# MAJESTIC COMMERCENTER PHASE II

# AURORA, COLORADO

MAJESTIC COMMERCENTER FILING NO. 2  
**BUILDING 9 ADDITIONAL PARKING**  
 COVER SHEET & NOTES

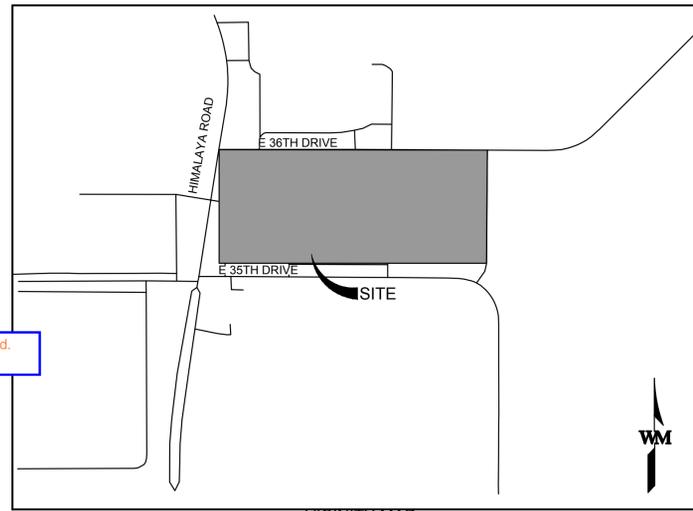
Add when landscaping is expected to be installed. This was requested previously and should be done upon completion of the parking lot expansion.

Include the proposed canopy addition in the description of the proposed changes.

Add the following notes as applicable:  
 - NOTES FOR ELECTRONICALLY OPERATED GATES:  
 1. THE DEVELOPER, HIS OR HER SUCCESSORS, AND ASSIGNS SHALL BE RESPONSIBLE FOR INSTALLATION, MAINTENANCE, AND REPLACEMENT OF THE ACCESS CONTROL GATE OR BARRIER SYSTEM TO ENSURE EMERGENCY VEHICLE ACCESS TO WITHIN THE SITE. IF THE ABOVE CONDITIONS ARE NOT MET, THE OWNERS, HIS OR HER SUCCESSORS, AND ASSIGNS, SHALL BE REQUIRED BY FIRE DEPARTMENT ORDER NOTICE THAT ALL AFFECTED GATES BE CHAINED AND LOCKED IN THE OPEN POSITION UNTIL REPAIRED OR REPLACED, AND RETESTED TO ALL CITY OF AURORA STANDARDS AT THE TIME OF THE VIOLATION. IF THE GATING SYSTEM IS NOT MAINTAINED TO THE SATISFACTION OF THE FIRE DEPARTMENT, THE LICENSE FOR THE EMERGENCY VEHICLE GATE OPENING SYSTEM WILL BE REVOKED AND THE GATING SYSTEM MUST BE REMOVED. ELECTRONIC GATING SYSTEMS SHALL INCLUDE AN EMERGENCY VEHICLE GATE OPENING SYSTEM UTILIZING A REDUNDANCY BACK-UP SYSTEM THAT CONSISTS OF: A) SIREN OPERATED SYSTEM; B) AUTOMATIC KNOX KEY SWITCH; AND C) MANUAL OVERRIDE (IN THE EVENT OF SYSTEM FAILURE). GATING SYSTEMS WILL BE INSTALLED IN ACCORDANCE WITH THE "GATING SYSTEMS CROSSING FIRE APPARATUS ACCESS ROADS CHECKLIST".

Requested addition to note added.

Canopy addition added to amendment block.

Note added to cover sheet.

Notes for electronic and manually operated gates added to cover sheet and bubbled.

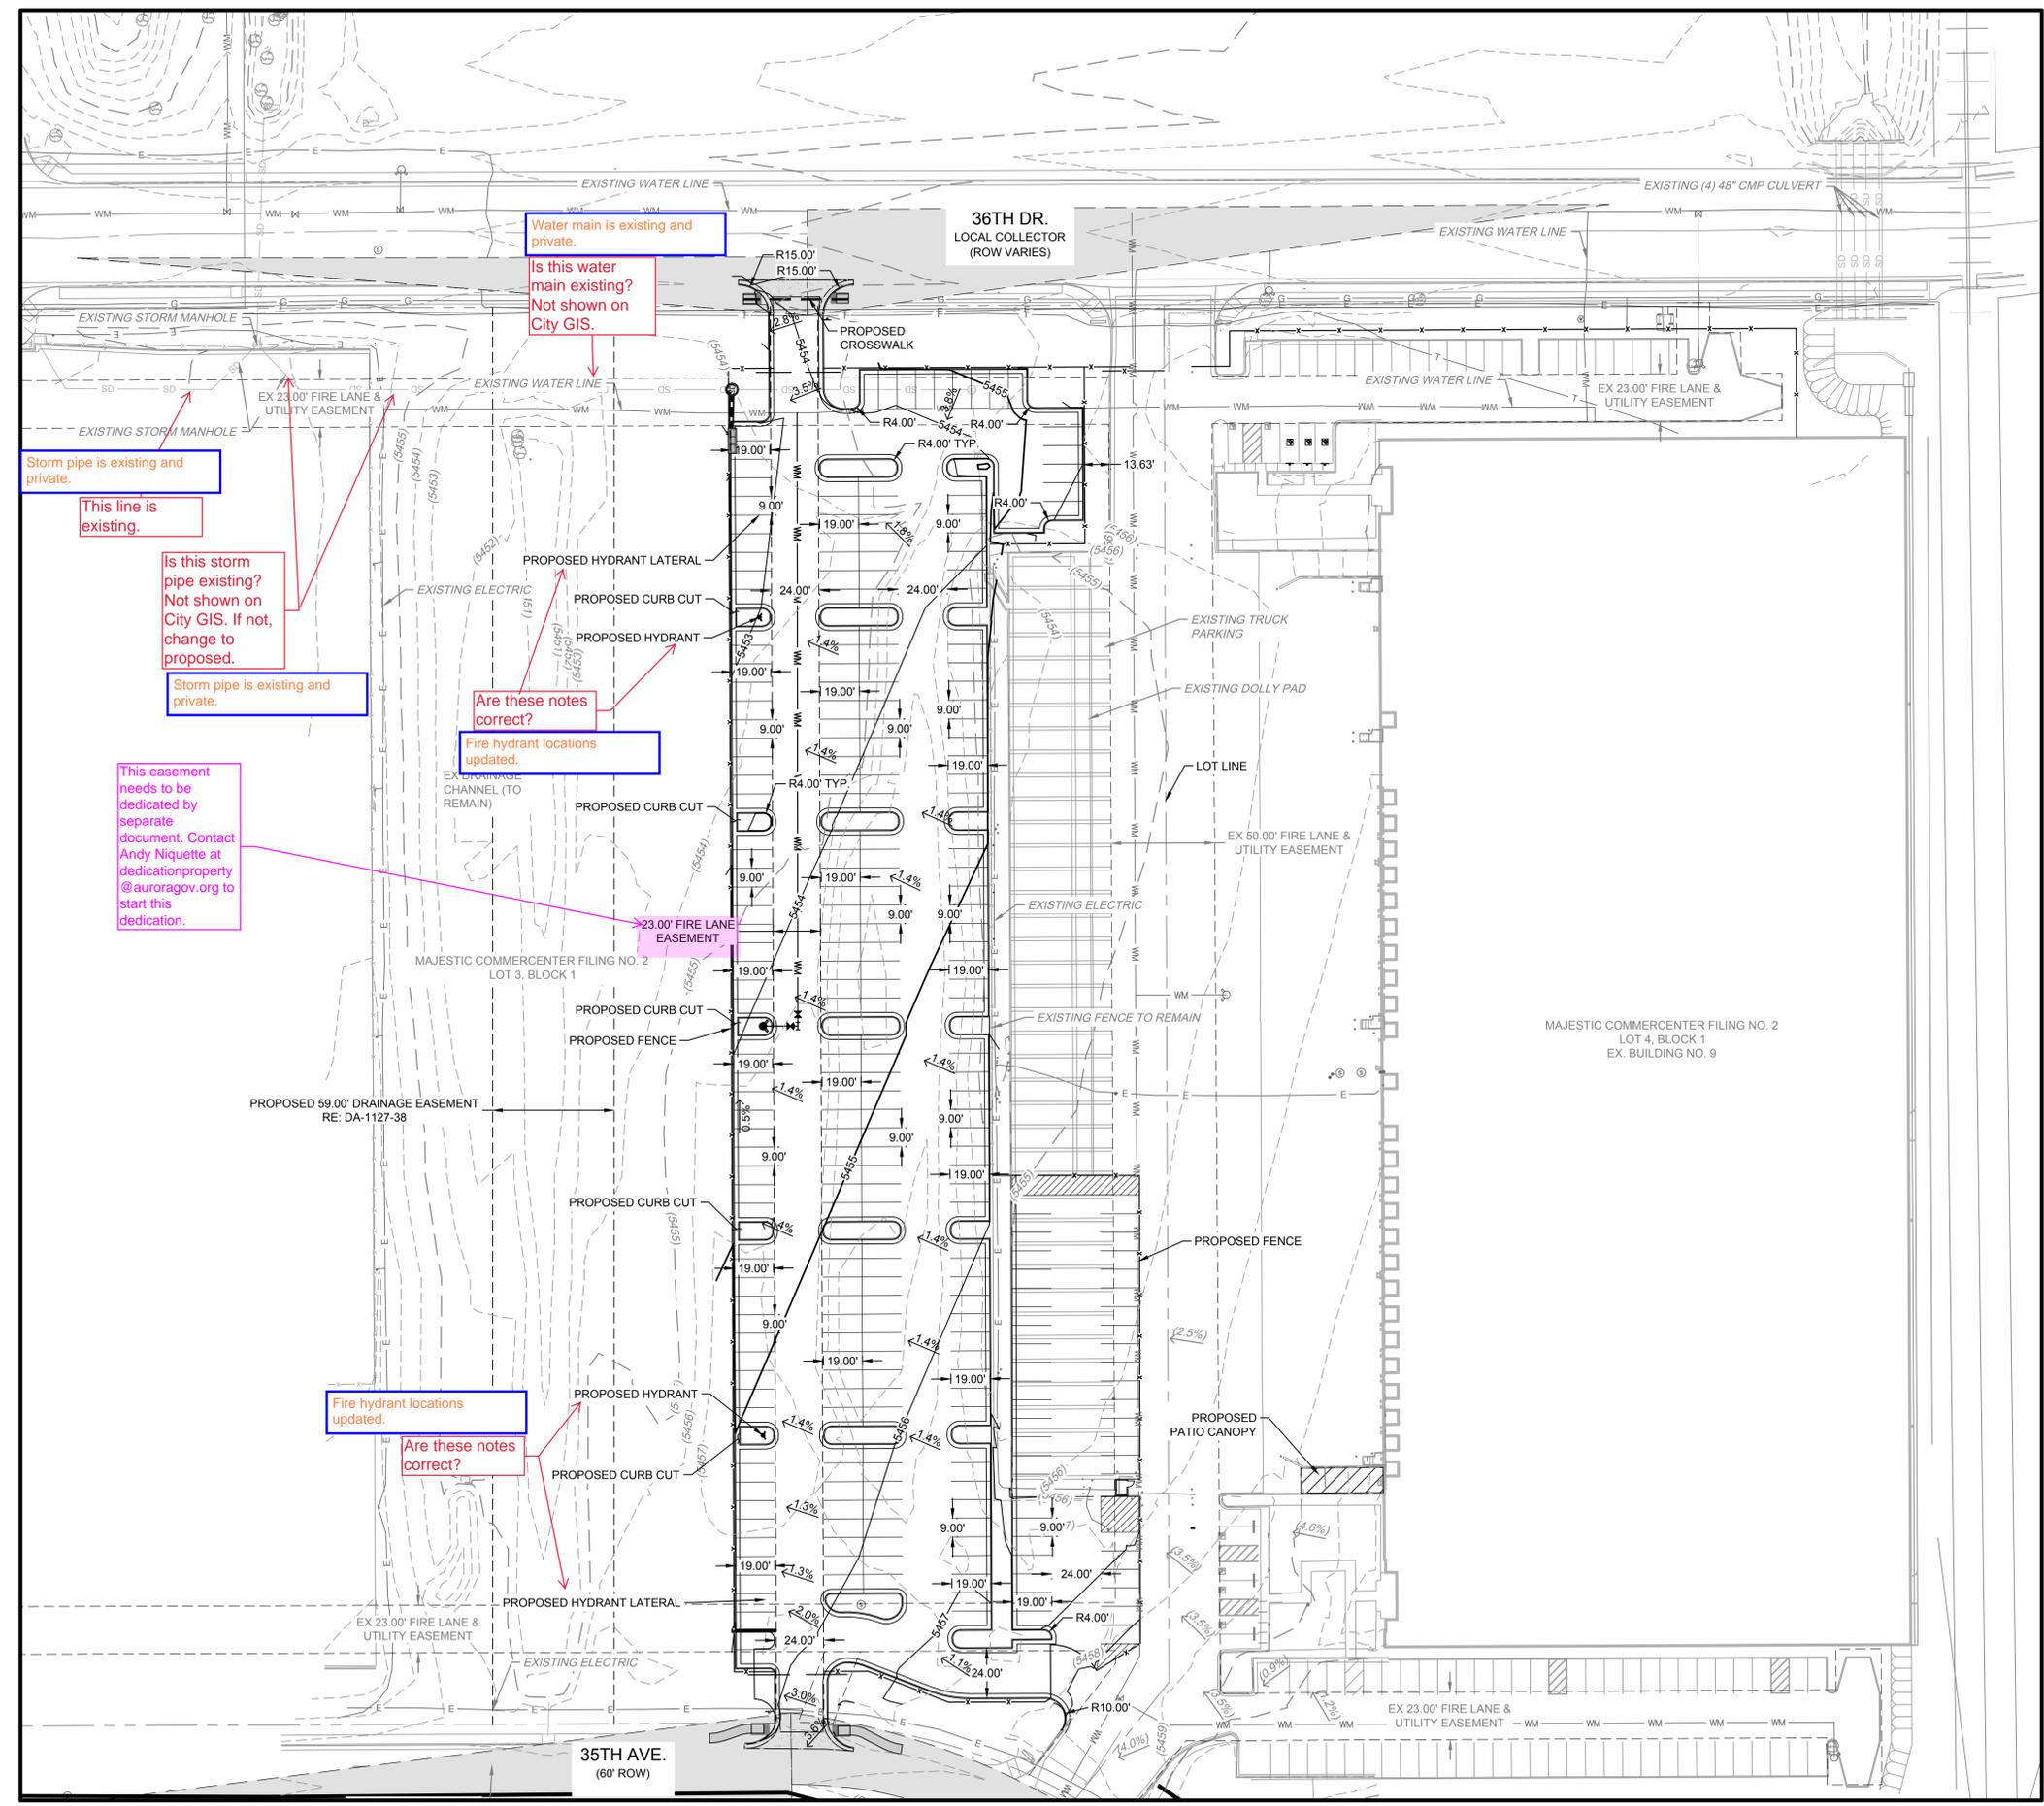
Water main is existing and private.  
Is this water main existing? Not shown on City GIS.

Is this storm pipe existing? Not shown on City GIS. If not, change to proposed.  
Storm pipe is existing and private.

Are these notes correct?  
Fire hydrant locations updated.

This easement needs to be dedicated by separate document. Contact Andy Niquette at dedicationproperty@auroragov.org to start this dedication.

Storm pipe is existing and private.  
This line is existing.

Fire hydrant locations updated.  
Are these notes correct?
